**Subject: Response to Portion of NRC Request for Additional Information
Letter No. 208 - Related To NEDO-33338, "ESBWR Feedwater
Temperature Operating Domain For Transient And Accident
Analysis" – RAI Number 4.3-17**

**Related to NEDO-33338, “ESBWR Feedwater Temperature
Operating Domain For Transient And Accident Analysis”**

RAI Number 4.3-17

DCD and LTR Markups

Figure 4.3-17-1 ESBWR Core Power-FW Temperature Operating Domain with Representative Rod/FW Temperature Block and Scram Lines

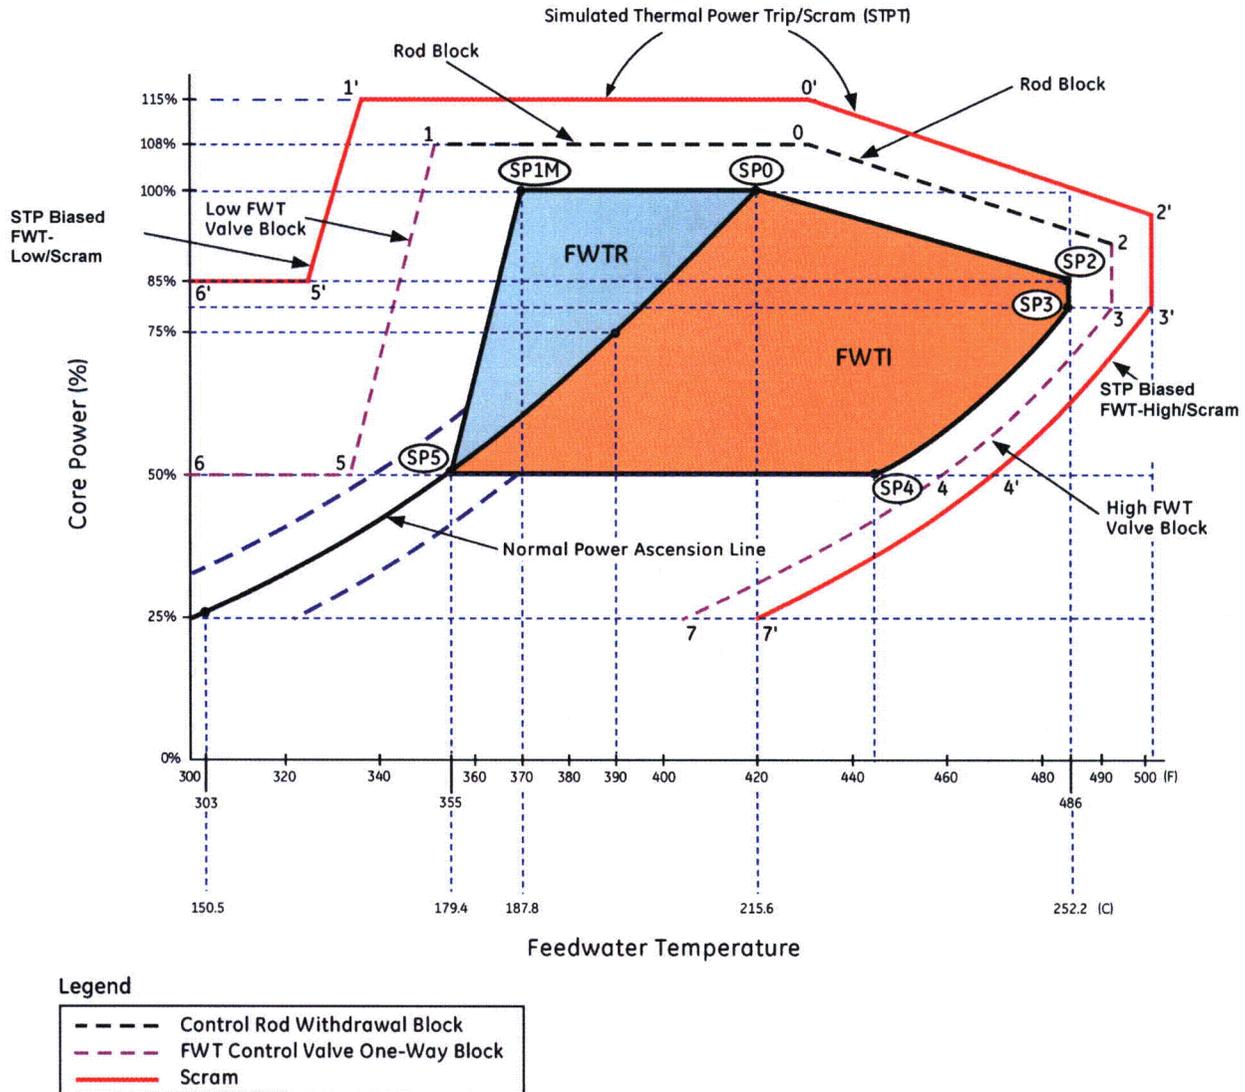
Put lines for rod block, control system action, and protection system actuation in FWTOD map.

Provide in graphical form the power-temperature operating map showing the most relevant lines for alarms (e.g. rod block), control system action, and protection system actuation.

GEH response to RAI 4.3-16 (submitted in MFN 08-790 dated October 20, 2008) provides an updated Core Power – Feedwater Temperature Operating Domain (P-FWTOD) or map. Figure 4.3-17-1 of this response provides the lines for rod block, control system action and protection system actuation in the updated P-FWTOD.

The specific protective action lines in Figure 4.3-17-1 are as follows:

1. To limit the power increase above the SP1M-to-SP0 line, a control rod withdrawal block (along with alarm) is initiated at 108% power as per Table 7.2-4 of Reference 4.3-17-1. This is shown as the horizontal 'black dashed line' 1-0 in Figure 4.3-17-1. For feedwater temperatures above 222.2°C (432°F), this rod withdrawal block line (with alarm) is sloped downward parallel to the RPS scram line (Feedwater Temperature Biased Simulated Thermal Power – High), discussed below, with 7% lower reactor rated power from the RPS scram line. This rod withdrawal block line is shown as the 'black dashed line' 0-2. The core power and FW temperature at State Point 0 are 108% and 222.2°C (432°F), and those at State Point 2 are 92.1% and 256.2°C (493.2°F).

If the reactor power reaches 108%, i.e., Line 1-0, because of FW temperature reduction due to open high-pressure FW heaters bypass valves, a FW temperature control valve one-way block (to prevent further opening of these bypass valves) is initiated along with alarm. This is to limit FW temperature reduction, and thereby limit further power increase. Similar one-way valve block is discussed in Item # 3 below.

2. If the reactor power increases further (above the SP1M-to-SP0 line), RPS trips and scrams the reactor at 115% power (shown by the horizontal 'red solid line' 1'-0') as per Table 7.2-4 of Reference 4.3-17-1. The RPS scram line (Feedwater Temperature Biased Simulated Thermal Power – High) is shown as the 'red solid line' 0'-2' as per Table 15.2-1 (for feedwater water temperatures above 222.2°C (432°F)) of Reference 4.3-17-1. The core power and FW temperature at State Point 0' are 115% and 222.2°C (432°F), and those at State Point 2' are 97.3% and 260.2°C (500.4°F).

3. To limit FW temperature reduction, and thereby power increase, a FW temperature control valve one-way block (to prevent further opening of the high-pressure FW heaters bypass valves) is initiated along with alarm beyond the Left Hand Side of the SP1M-SP5 line. This is shown as the 'purple dashed line' 1-5, which is parallel to the SP1M-SP5 line with a constant FW temperature offset of 11.1°C (20°F). If the reactor departs further to the left of this purple dashed line, the RPS scram (Simulated Thermal Power Biased Feedwater Temperature – Low) is initiated, which is shown as the 'red solid line' 1'-5', parallel to the SP1M-SP5 line with a constant FW temperature offset of 22.2°C (40°F). This scram is terminated at 85% power (Horizontal Line 5'-6') to allow Generator Load Rejection/Turbine Trip with Turbine Bypass to proceed without scram (Subsections 15.2.2.2 and 15.2.2.4 of Reference 4.3-17-1). No one-way valve block is implemented at powers below 50% of rated power, which is depicted by the horizontal 'purple dashed' line 5-6 at 50% power.

4. To limit the FW temperature increase at the Right Hand Side of the SP2-SP3-SP4 line, a similar FW temperature control valve one-way block (to prevent further opening of the steam valves for the 7th stage FW heaters) is initiated along with alarm. This is depicted by the 'purple dashed line' 2-3-4 (with a constant FW temperature offset of 4°C [7.2°F] from the SP2-SP3-SP4 line). If the reactor departs further to the right of this purple dashed line, the RPS scram (Simulated Thermal Power Biased Feedwater Temperature – High) is initiated, which is shown by the 'red solid line' 2'-3'-4' with a constant FW temperature offset of 8°C (14.4°F) from the SP2-SP3-SP4 line.

From 50% to 25% power, these valve block and scram lines (2-3-4 and 2'-3'-4') are extended as 4-7 and 4'-7' lines parallel to the "Normal Power Ascension Line" with constant FW temperature offsets of 54°C (97.2°F) and 58°C (104.4°F), respectively. These valve block and scram lines (4-7 and 4'-7') are terminated at 25% power since there is significant margin to thermal limits and thermal limit monitoring is not required at powers below 25%.

Figure 15.2-17. ESBWR Core Power-FW Temperature Operating Domain with Representative Rod/FW Temperature Block and Scram Lines

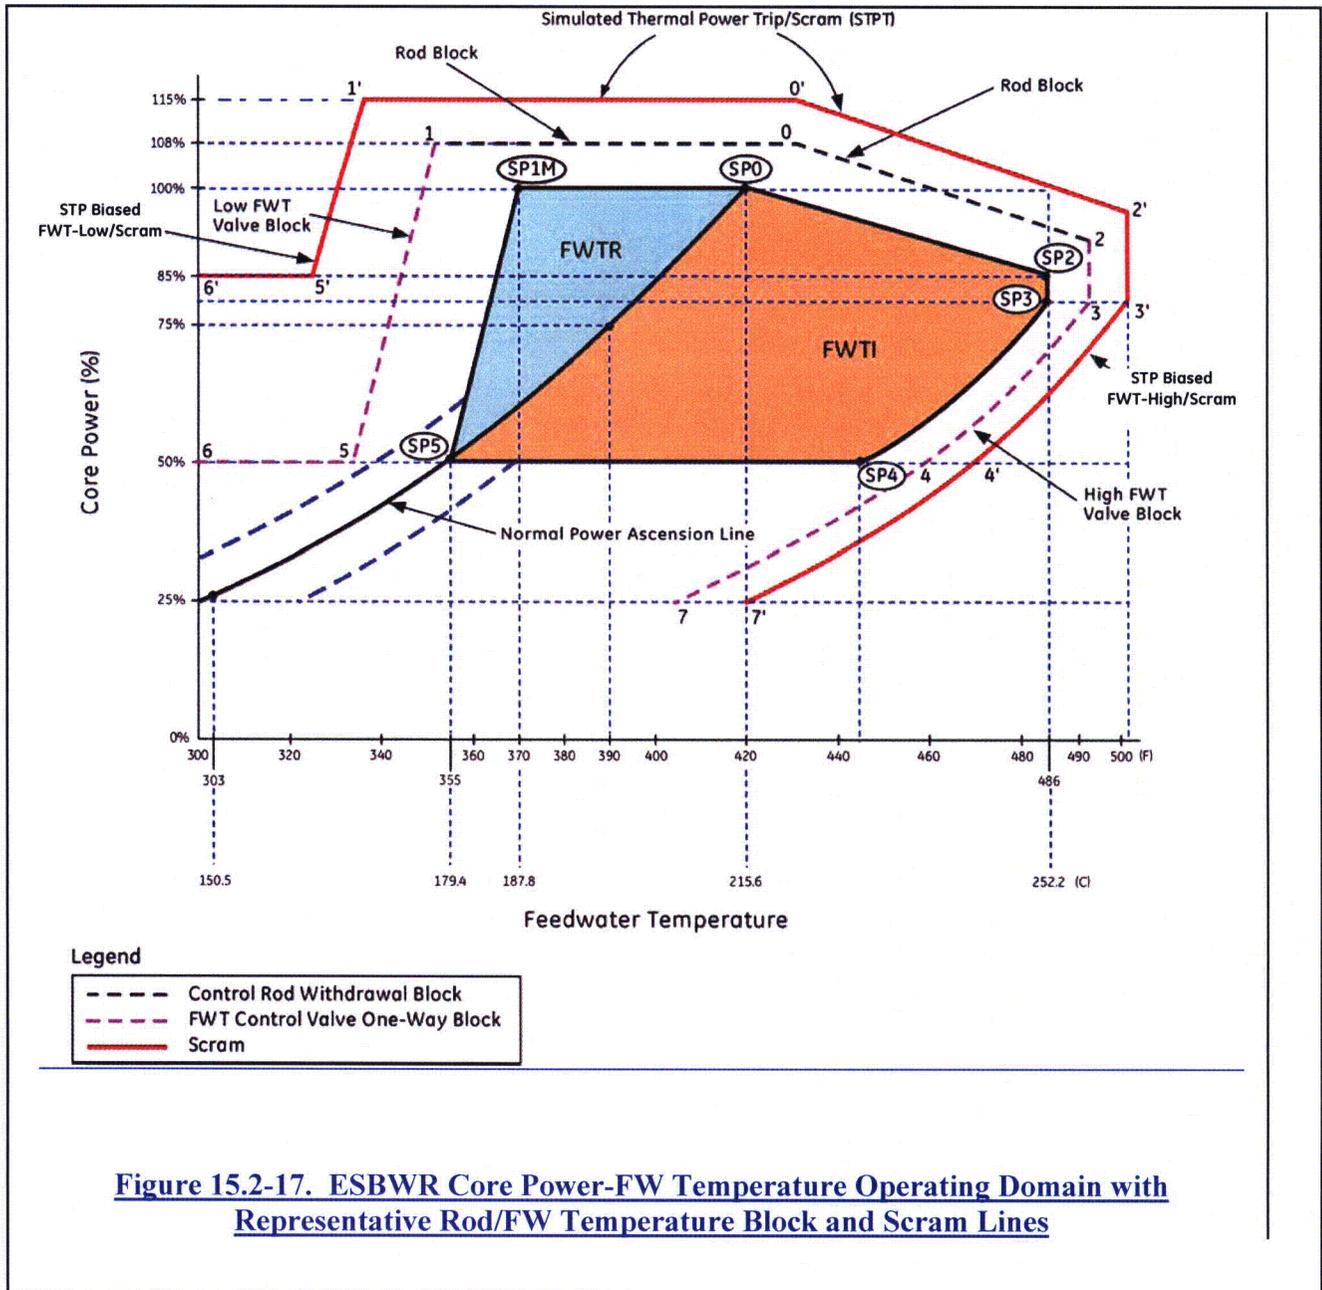
DCD Chapter 15 Section 15.2 and Figure 15.2-17 will be revised as per the DCD markup in Enclosure 2 in response to this RAI.

For the core power-feedwater temperature operating domain as discussed in Subsection 4.4.4.3, Figure 15.2-17 shows the lines for rod block, control system action and protection system actuation. The details are discussed in Reference 15.2-5.

Figure 4.2-2 ESBWR Power-FW Temperature Operating Domain with Representative Rod/FW Temperature Block and Scram Lines

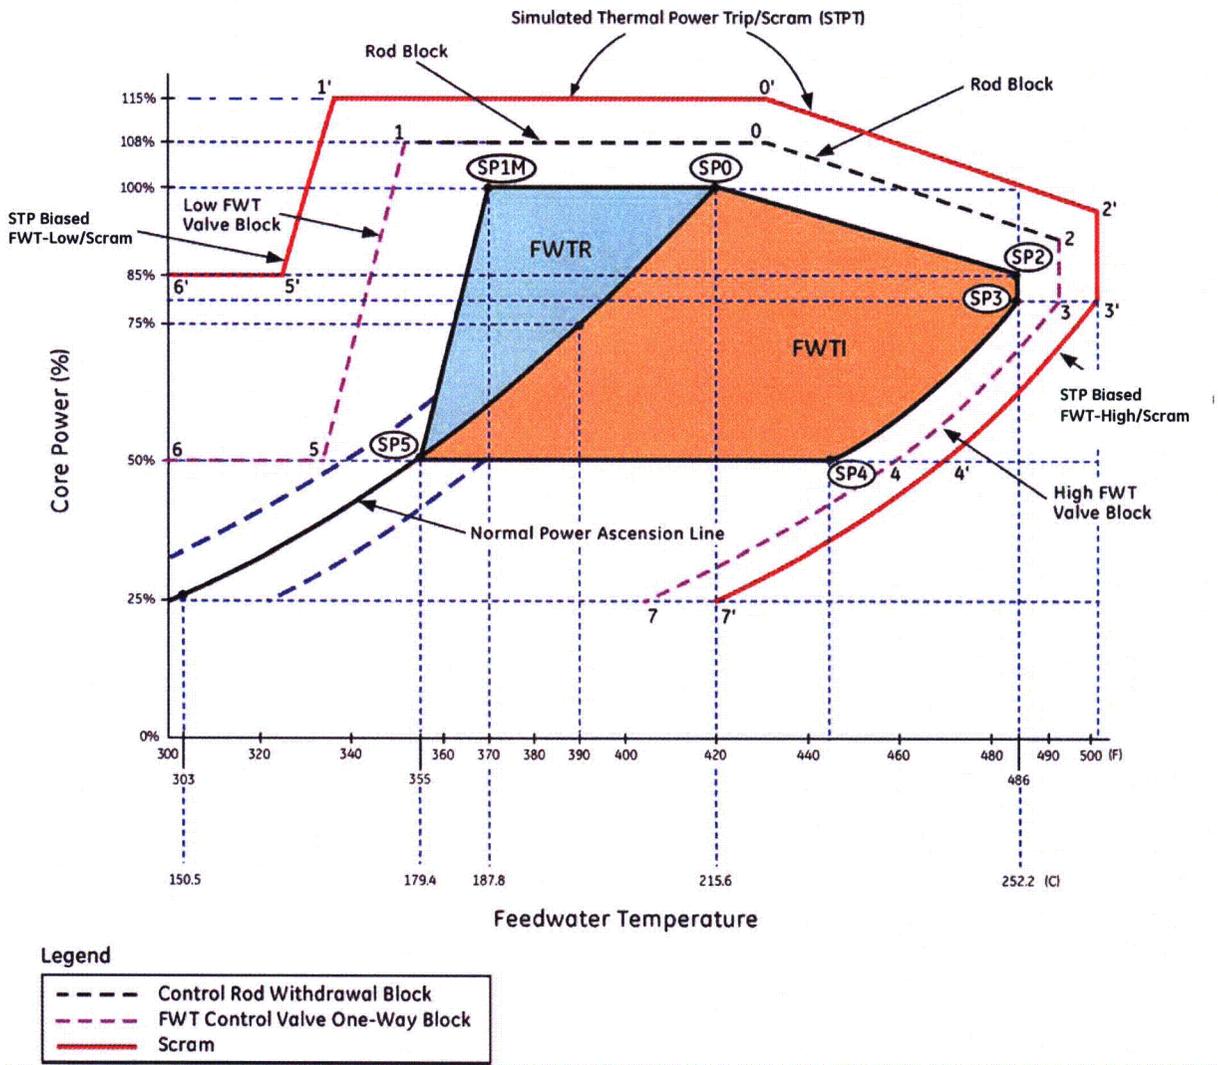
The subject LTR (NEDO-33338), Section 4.2, will be revised as per the LTR markup in Enclosure 2 in response to this RAI.

Figure 4.2-2 provides the lines for rod block, control system action and protection system actuation in the ESBWR Power – FW temperature operating domain or P-FWTOD. The details are discussed below:

- (1) To limit the power increase above the SP1M-to-SP0 line, a control rod withdrawal block (along with alarm) is initiated at 108% power as per Table 7.2-4 of Reference 4.2-1. This is shown as the horizontal ‘black dashed line’ 1-0 in Figure 4.2-2. For feedwater temperatures above 222.2°C (432°F), this rod withdrawal block line (with alarm) is sloped

downward parallel to the RPS scram line (Feedwater Temperature Biased Simulated Thermal Power – High), discussed below, with 7% lower reactor rated power from the RPS scram line. This rod withdrawal block line is shown as the ‘black dashed line’ 0-2. The core power and FW temperature at State Point 0 are 108% and 222.2°C (432°F), and those at State Point 2 are 92.1% and 256.2°C (493.2°F).

If the reactor power reaches 108%, i.e., Line 1-0, because of FW temperature reduction due to open high-pressure FW heaters bypass valves, a FW temperature control valve one-way block (to prevent further opening of these bypass valves) is initiated along with alarm. This is to limit FW temperature reduction, and thereby limit further power increase. Similar one-way valve block is discussed in Item # 3 below.

- (2) If the reactor power increases further (above the SP1M-to-SP0 line), RPS trips and scrams the reactor at 115% power (shown by the horizontal ‘red solid line’ 1’-0’) as per Table 7.2-4 of Reference 4.2-1. The RPS scram line (Feedwater Temperature Biased Simulated Thermal Power – High) is shown as the ‘red solid line’ 0’-2’ as per Table 15.2-1 (for feedwater water temperatures above 222.2°C (432°F)) of Reference 4.2-1.

- (3) To limit FW temperature reduction, and thereby power increase, a FW temperature control valve one-way block (to prevent further opening of the high-pressure FW heaters bypass valves) is initiated along with alarm beyond the Left Hand Side of the SP1M-SP5 line. This is shown as the ‘purple dashed line’ 1-5, which is parallel to the SP1M-SP5 line with a constant FW temperature offset of 11.1°C (20°F). If the reactor departs further to the left of this purple dashed line, the RPS scram (Simulated Thermal Power Biased Feedwater Temperature – Low) is initiated, which is shown as the ‘red solid line’ 1’-5’, parallel to the SP1M-SP5 line with a constant FW temperature offset of 22.2°C (40°F). This scram is terminated at 85% power (Horizontal Line 5’-6’) to allow Generator Load Rejection/Turbine Trip with Turbine Bypass to proceed without scram (Subsections 15.2.2.2 and 15.2.2.4 of Reference 4.2-1). No one-way valve block is implemented at powers below 50% of rated power, which is depicted by the horizontal ‘purple dashed’ line 5-6 at 50% power.

- (4) To limit the FW temperature increase at the Right Hand Side of the SP2-SP3-SP4 line, a similar FW temperature control valve one-way block (to prevent further opening of the steam valves for the 7th stage FW heaters) is initiated along with alarm. This is depicted by the ‘purple dashed line’ 2-3-4 (with a constant FW temperature offset of 4°C [7.2°F] from the SP2-SP3-SP4 line). If the reactor departs further to the right of this purple dashed line, the RPS scram (Simulated Thermal Power Biased Feedwater Temperature – High) is initiated, which is shown by the ‘red solid line’ 2’-3’-4’ with a constant FW temperature offset of 8°C (14.4°F) from the SP2-SP3-SP4 line.

From 50% to 25% power, these valve block and scram lines (2-3-4 and 2’-3’-4’) are extended as 4-7 and 4’-7’ lines parallel to the “Normal Power Ascension Line” with constant FW temperature offsets of 54°C (97.2°F) and 58°C (104.4°F), respectively. These valve block and scram lines (4-7 and 4’-7’) are terminated at 25% power since there is significant margin to thermal limits and thermal limit monitoring is not required at powers below 25%.
